Reliability Standard and Settings Review
AEMC Reference: REL0034

The National Generators Forum (NGF) welcomes the opportunity to comment on the Reliability Standard and Settings Draft Report - "Draft Report" and accompanying consulting report by ROAM Consulting, released by the AEMC Reliability Panel (Panel) on 23 December 2009.

Figure 1: Ratio of Victorian energy and demand levels, indexed to 2010

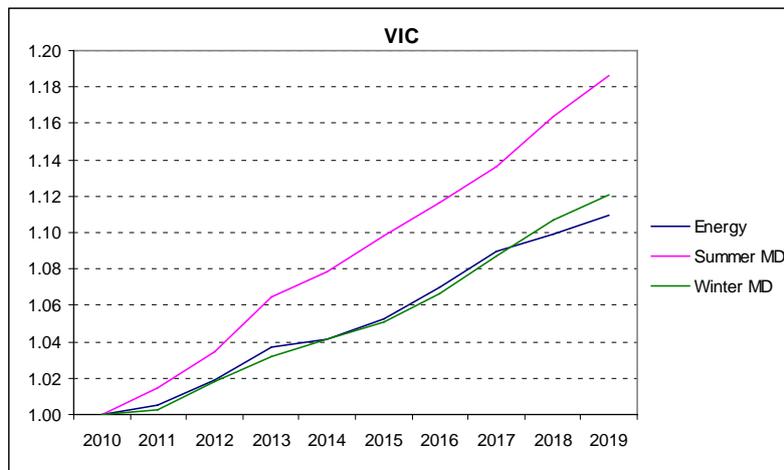
Energy demand is likely to become 'peakier' in the next 10 years as illustrated by the sample charts of Electricity Statement of Opportunities (ESOO) 2009 data, and result in more large magnitude, short duration USE events. This will reduce the number of hours a marginal OCGT can run to recover its capital costs for a given level of USE reliability standard. As a result, the MPC will need to increase to meet the reliability standard.

In addition, the increased penetration of wind generation, as a consequence of the expanded Renewable Energy Target (RET), is likely to exasperate the peakiness of the load. The graphs below show this increased peakiness over time in Victoria and NSW.
